COUNTY OF BERKS

NOTICE TO BIDDERS

Amendment #2 Issued on May 8, 2023

Re: Invitation to Bid #23-12-GR

Schedule of Drawings – Amendment #2 – Sheet A-002 – Contractor Laydown Area and Code Summary

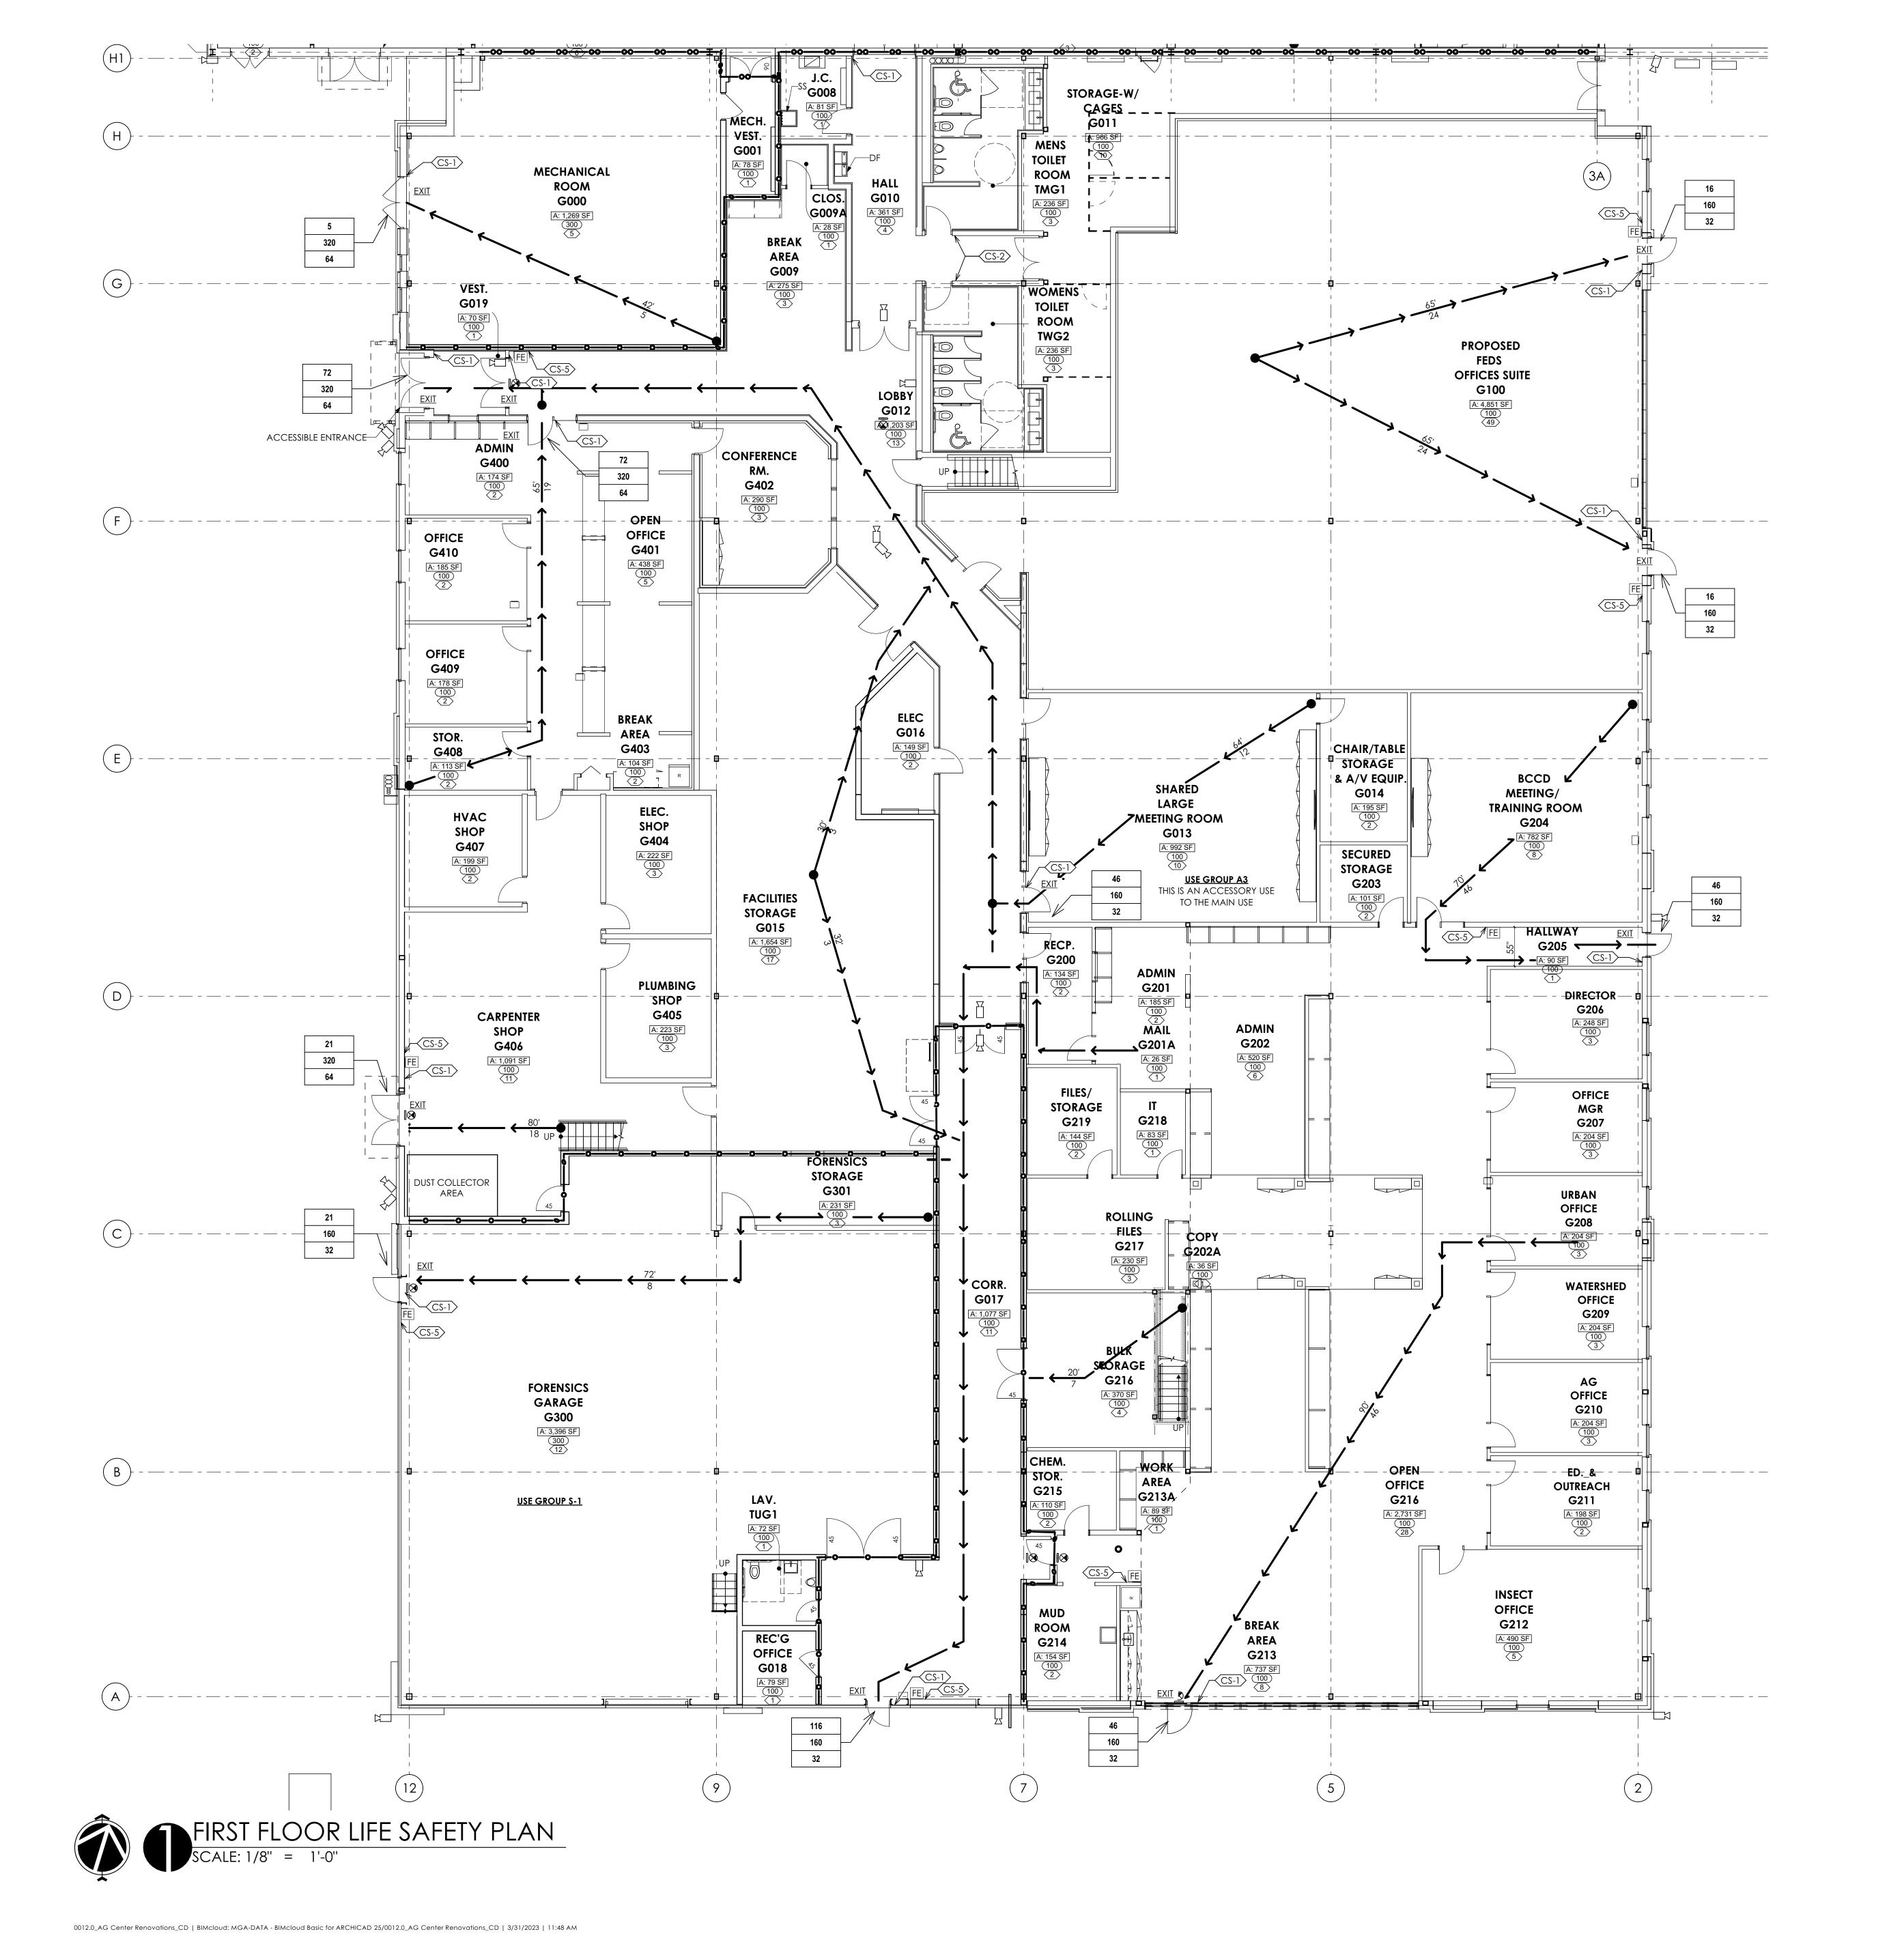
- Q17: In addition to the laydown area, are we demolishing the existing paved area to stone in and then restore to grass?
- A17: The existing paved/impervious paver area is to remain; it is not to be removed. The area shown on Sheet A-002, Contractor Laydown Area and Code Summary, of Schedule of Drawings Amendment #2, details the areas to be removed and replaced.

Schedule of Drawings – Amendment #2 – Sheet AD-101 – Demolition Plans

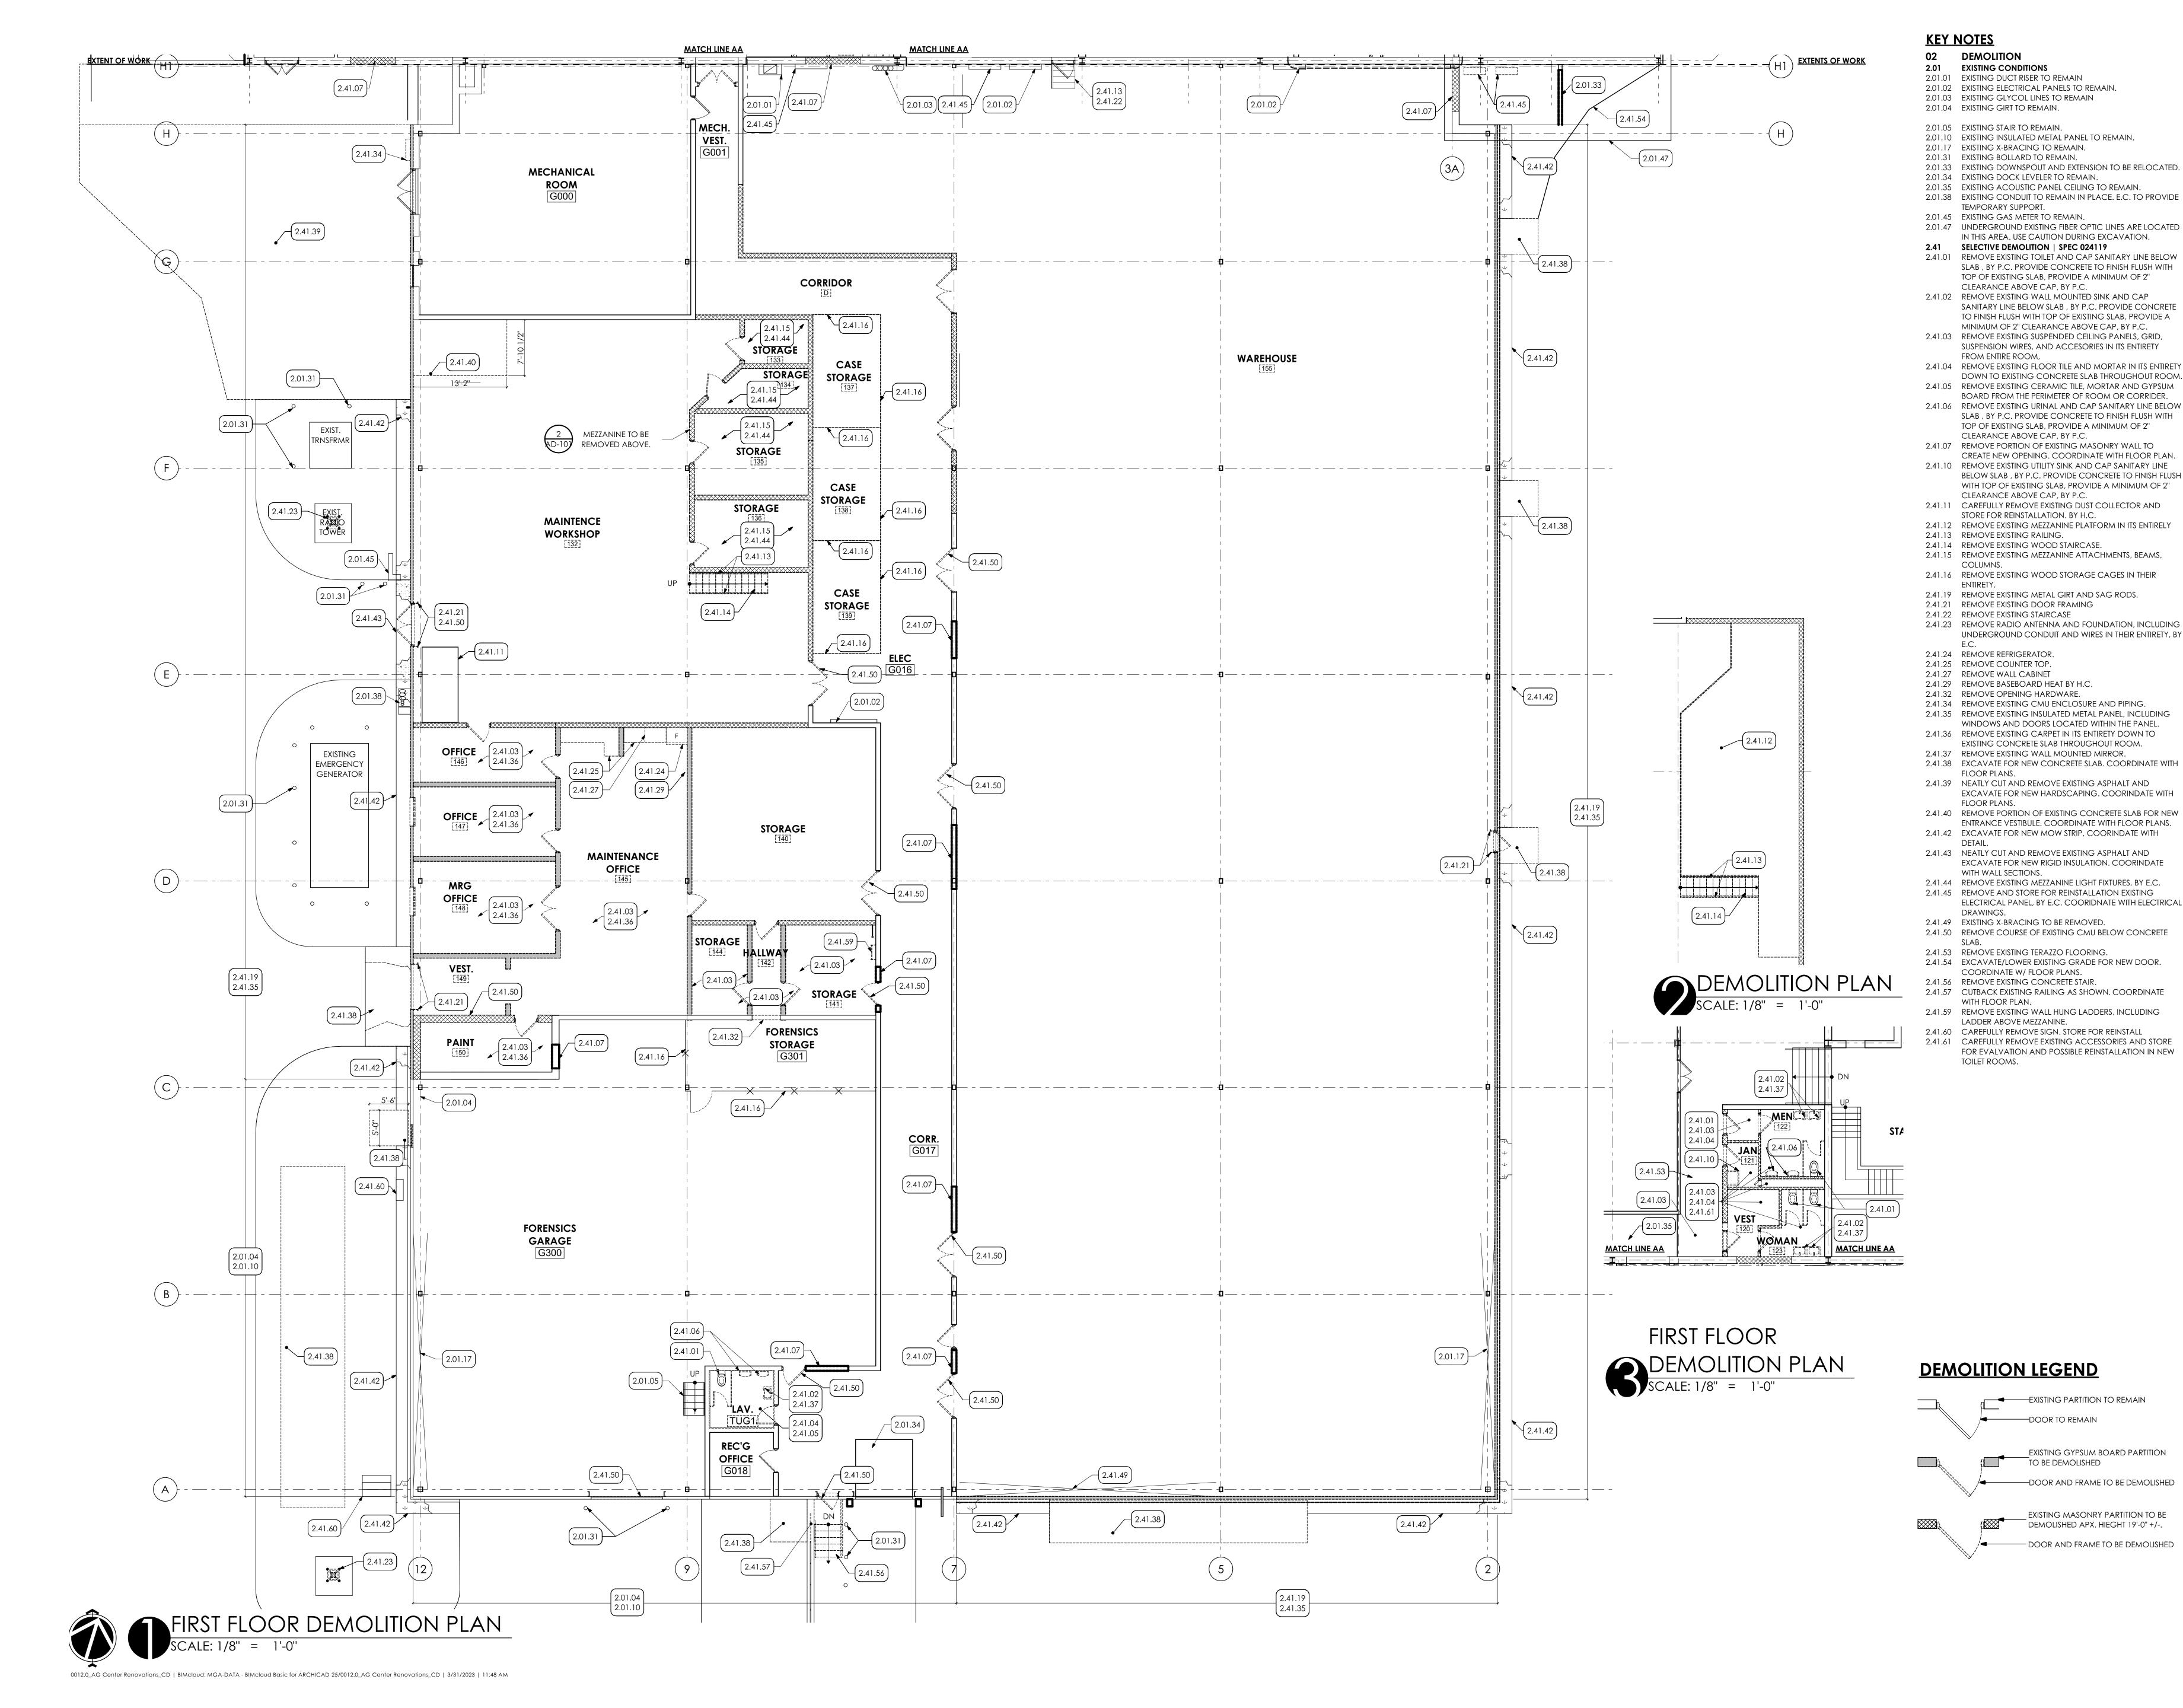
- Q18: Which Contractor will be responsible for removing and subsequently reinstalling the existing dust collector?
- A18: As per Keynote 2.41.11 on Sheet AD-101, Demolition Plans, on Schedule of Drawings Amendment #2, the HVAC Contractor (HC) shall remove the existing dust collector and store for reinstallation by the HC.
